Subject: Transmittal of Class 1 Permit Modification to Update Figures in the Los Alamos National Laboratory (LANL) Hazardous Waste Facility Permit, EPA ID No. NM0890010515

CLASS 1 PERMIT MODIFICATION NOTIFICATION STRUCTURE CHANGES AT TECHNICAL AREA 54

ENV-DO-14-0023

LAUR-13-29257

Figure 7: Technical Area 54, Area L, Security Fences, Entry Gates, and Entry Stations

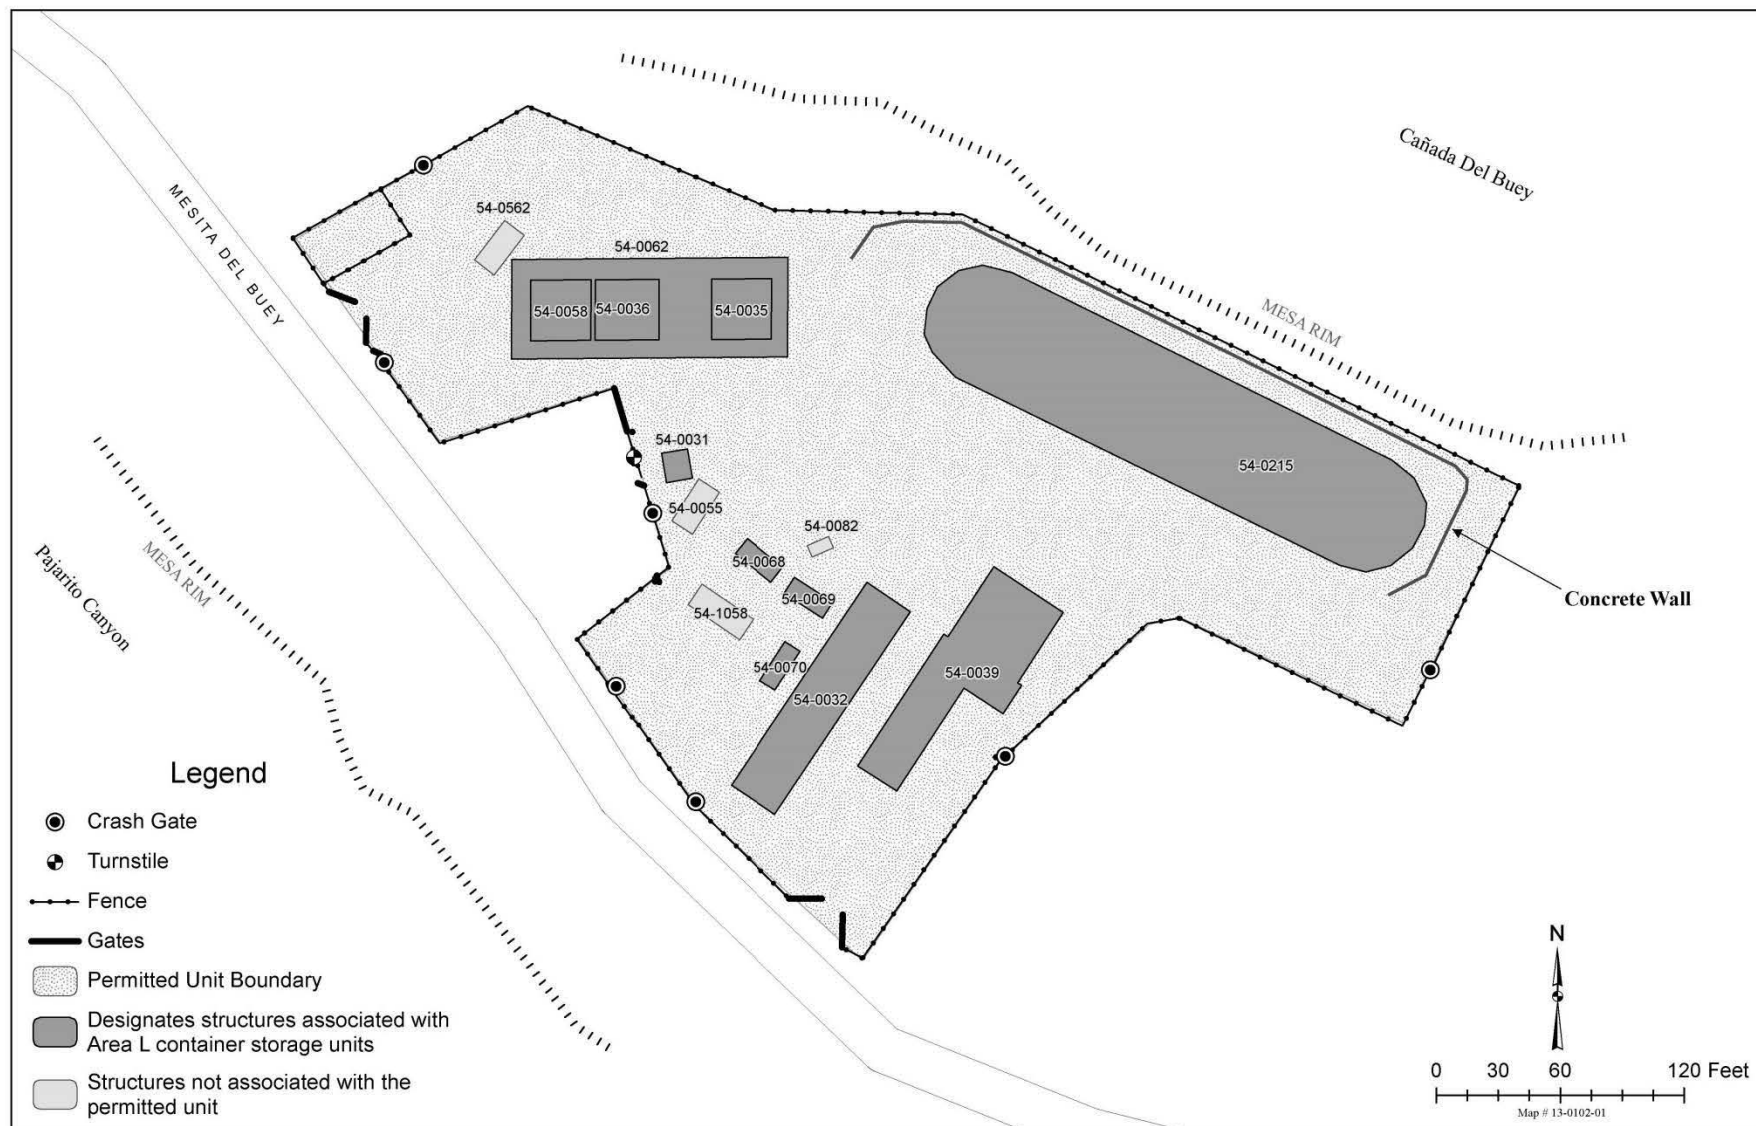
Figures 7 (Technical Area 54, Area L, Security Fences, Entry Gates, and Entry Stations) and 26 (Technical Area 54, Area L, Container Storage Unit) of Permit Attachment N, were revised to remove structure 54-46, the temporary fence, and the outline for the Perma-Con® located at the south end of structure 54-0032. As stated in the *Request for Class 2 Permit Modifications to the Los Alamos National Laboratory (LANL) Hazardous Waste Facility Permit* letter dated March 29, 2007, a proposal was made to relocate the Perma-Con® from the 54-36 structure to the 54-32 structure. The Perma-Con® was not relocated and was decommissioned instead. Additionally, the temporary fence shown in Figure 26 of Attachment N was not erected and therefore is not included in the revised figure. Structure 54-46 was removed from Area L; however, the structure was not designated as a structure that managed hazardous waste associated with the Area L container storage unit. Structure 54-0562, also not designated as a structure that manages hazardous waste associated with the permitted unit, has been added to Area L.

Figure 27: Technical Area 54, Area G, Container Storage Units

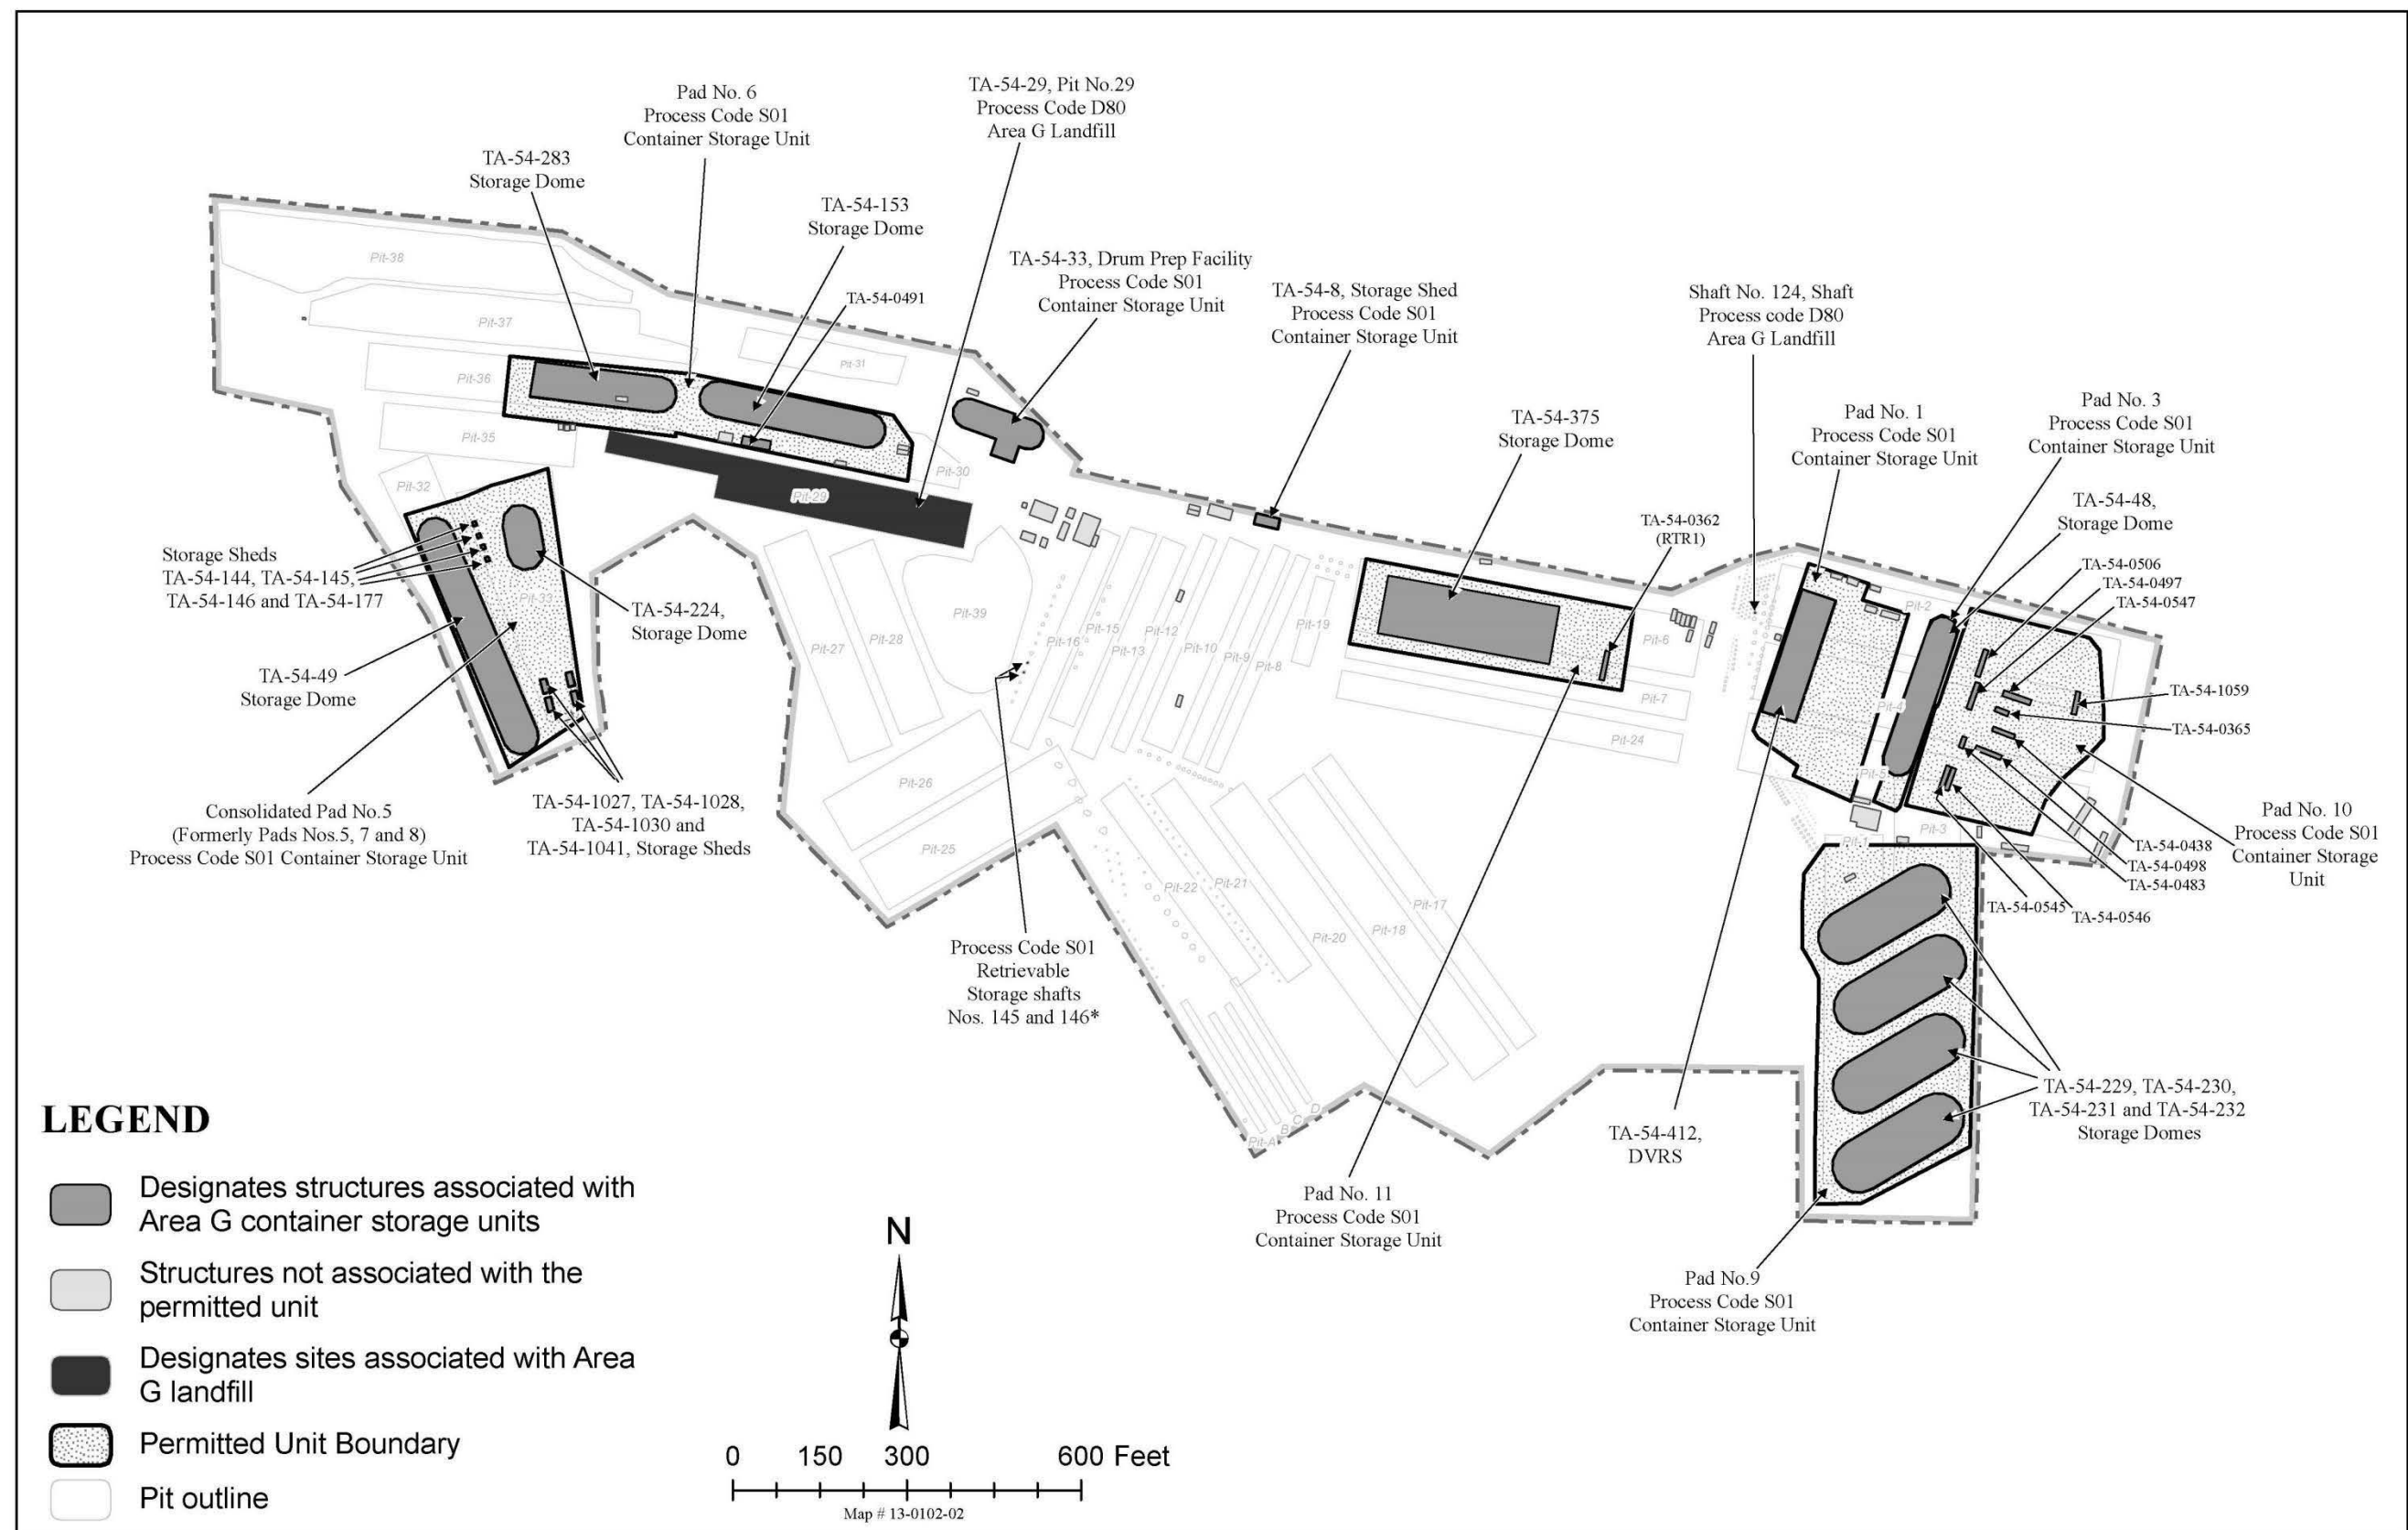
Figure 27 (Technical Area 54, Area G, Container Storage Units) of Attachment N was revised significantly to either remove structures that have been relocated or removed completely from Area G, to show the placement of new structures at Area G, or to label existing structures. Additionally, as a result of the Figure 27 update, some of the larger scale figures for units at TA-54

- Consolidated Pad No. 5- One of the five storage sheds was removed from the northern part of the pad, and two structures were removed from the center of the pad. All three structures removed were designated as structures that were not associated with the permitted unit and were not used to manage hazardous waste.

- Pad No. 6- Structure 54-0491 is a structure that is used for the storage of hazardous waste; however, in Figure 27 it was not identified as such nor was it labeled. The update to this figure includes labeling of Structure 54-0491 and designating it as a structure associated with the permitted unit. Storage Sheds 54-522 and 54-523 were removed from Pad 6 and Figure 27 has been updated to reflect this change. Storage Sheds 54-522 and 54-523 were designated as structures that were not associated with the permitted unit and were not used to manage hazardous waste.

- Pad No. 11- Pad 11 had three concrete barriers which are no longer present; therefore the two barriers were removed from Figure 27. Structure 54-0362 (RTR1) is associated with the permitted unit; however in Figure 27 it was not identified as such nor was it labeled. The update to this figure includes labeling of Structure 54-0362 (RTR1) and designating it as a structure associated with the permitted unit.

- Pad No. 9- Storage Shed 54-574 was moved and is currently located north of Dome 232. Storage Shed 54-484 was removed from the pad. Both 54-484 and 54-574 are designated as structures that are not associated with the permitted unit and are not used to manage hazardous waste.

- Pad No. 10- The structures located on Pad 10 were not labeled and were not clearly identified as structures used to manage hazardous waste. Figure 27 was updated to label the structures and to identify them as structures associated with the permitted unit.

Figure G.8-1: Technical Area 54, Area G, Pad 5, Outdoor Container Storage Unit Soil Sampling Grid and Additional Sampling Locations

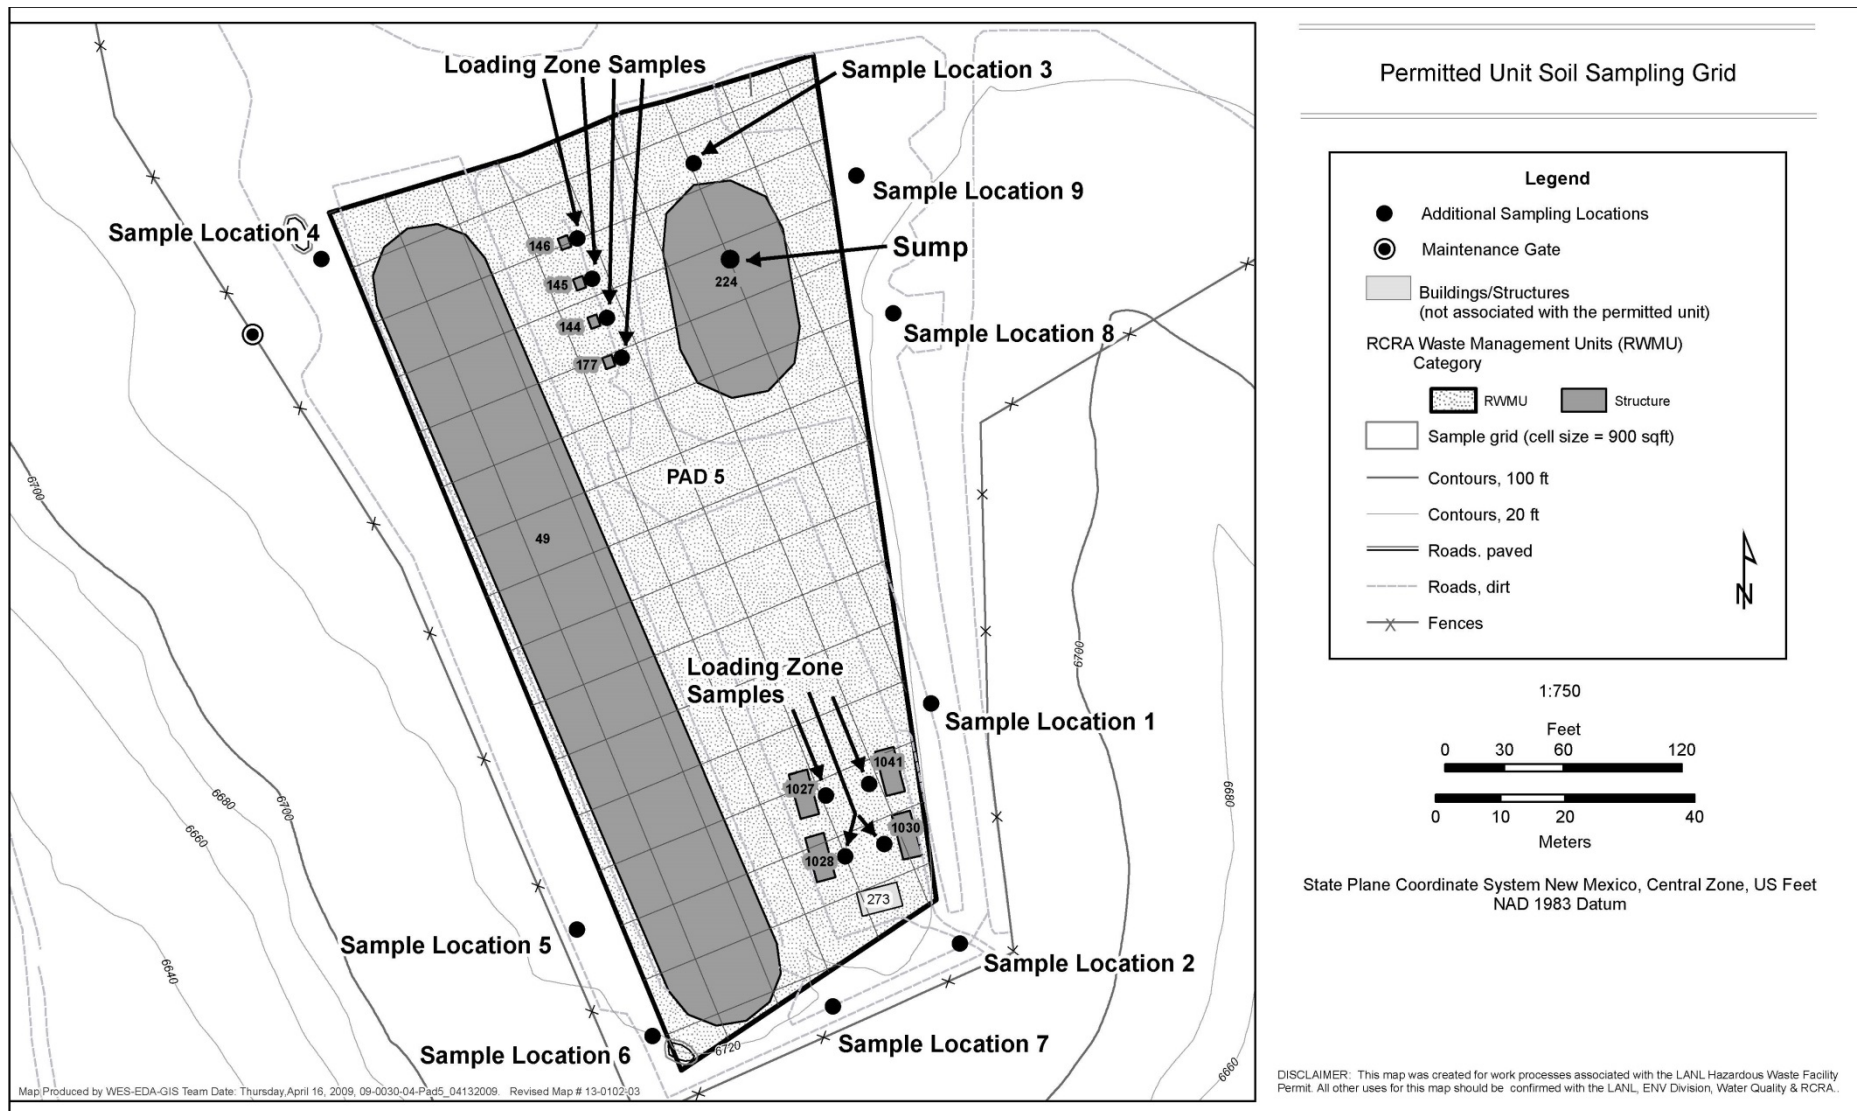
Figure G.8-1 (Technical Area 54, Area G, Pad 5, Outdoor Container Storage Unit Soil Sampling Grid and Additional Sampling Locations) of Attachment G.8 and Figure 32 (Technical Area (TA)-54, Area G, Pad 5 (Domes 49 and 224; Storage Sheds 144, 145, 146, 177, 1027, 1028, 1030 and 1041) of Attachment N, were modified to remove structures 54-465, 54-527, and 54-356. These structures were removed from the pad and Figures G.8-1 and 32 were updated to reflect this change. Additionally, a maintenance gate, located on the west side of the fence line was added to the figures. This change is consistent with the current Figure 8 of Attachment N.

Figure G.9-1: Technical Area 54, Area G, Pad 6 Outdoor Container Storage Unit Sampling Grid and Additional Sampling Locations

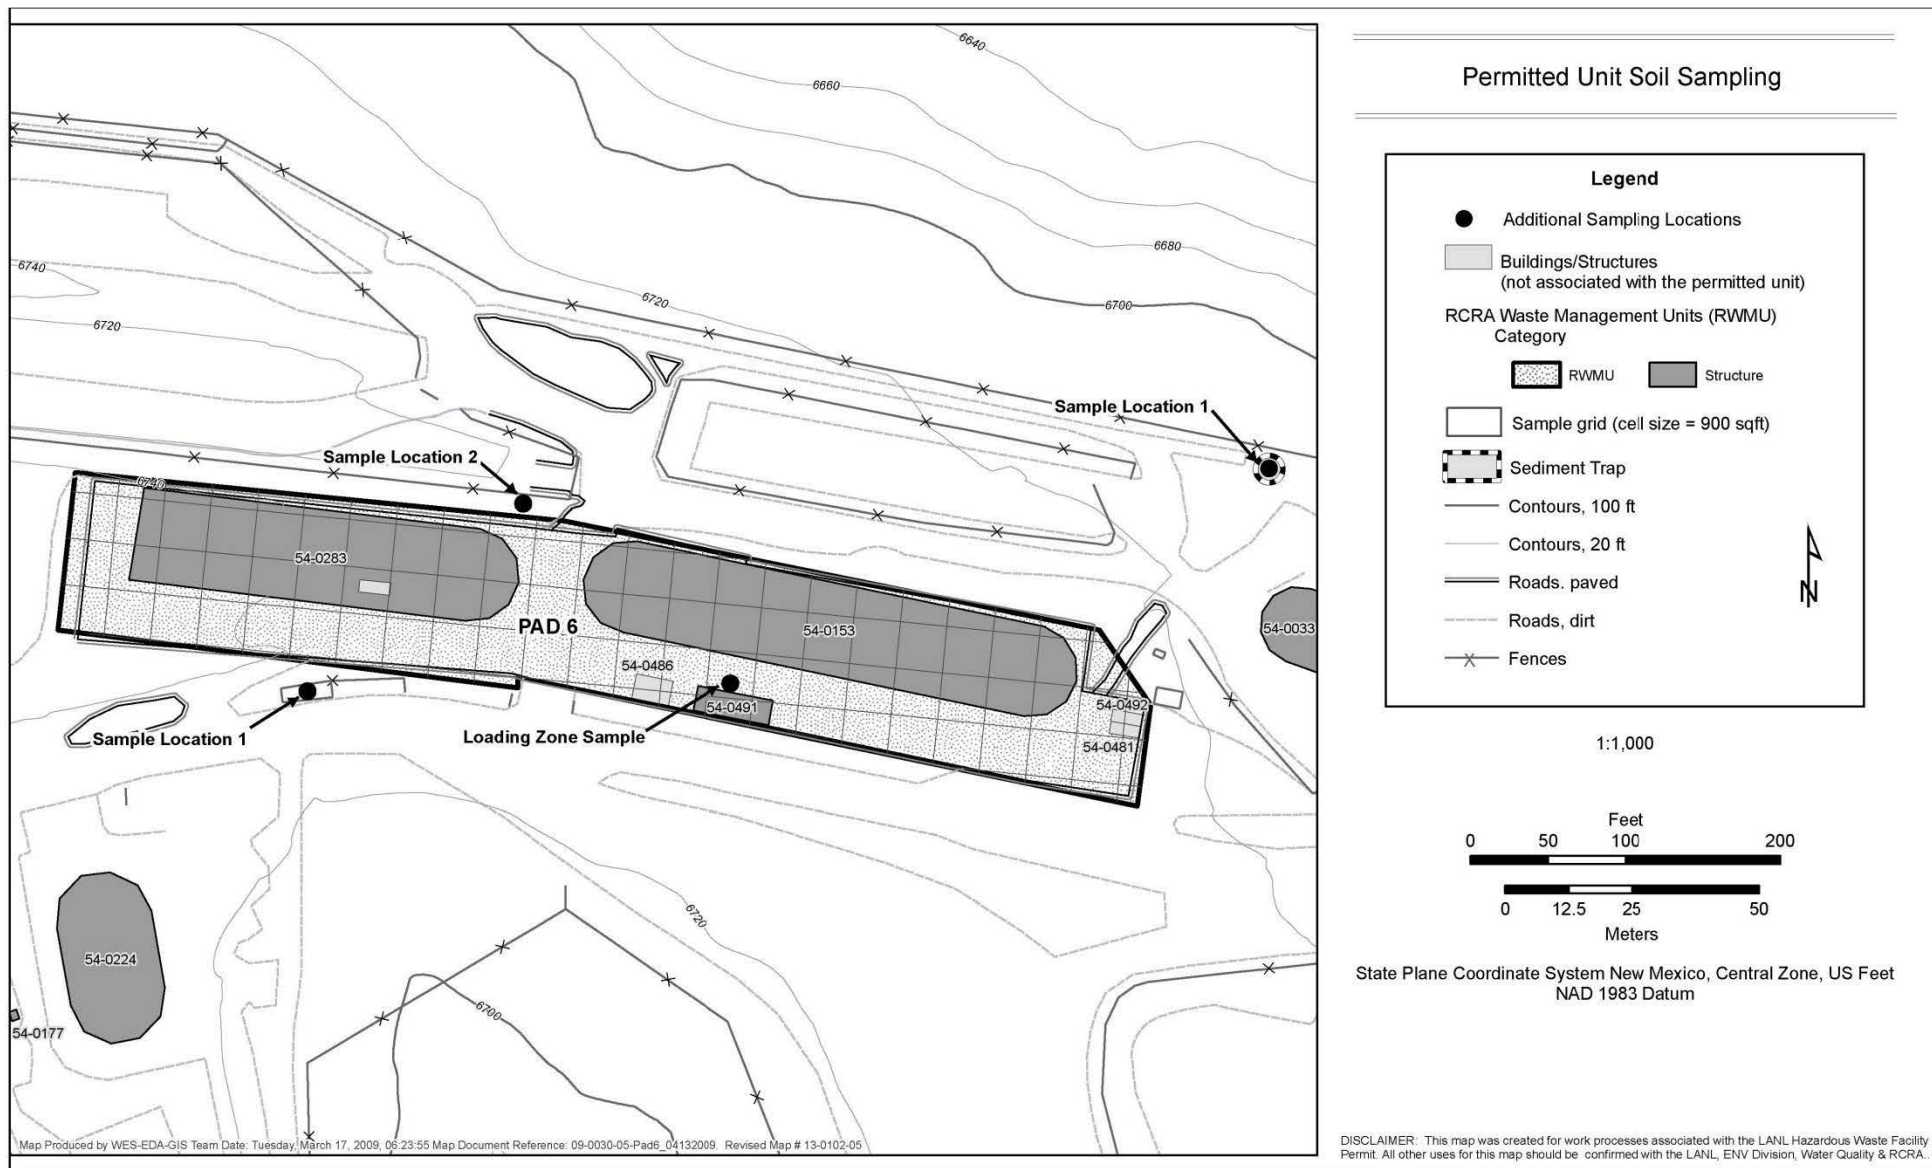
Figure G.9-1 (Technical Area 54, Area G, Pad 6 Outdoor Container Storage Unit Sampling Grid and Additional Sampling Locations) of Attachment G.9 and Figure 33 (Technical Area (TA)-54, Area G, Pad 6, (Domes 153 & 283)) of Attachment N were revised to remove structures 54-522 and 54-523. These structures were designated as structures that were not associated with the permitted unit and were not used to manage hazardous waste. The figure was also updated to reflect the addition

of a structure on the inside of structure 54-0283 that is not used to manage hazardous waste at the permitted unit.
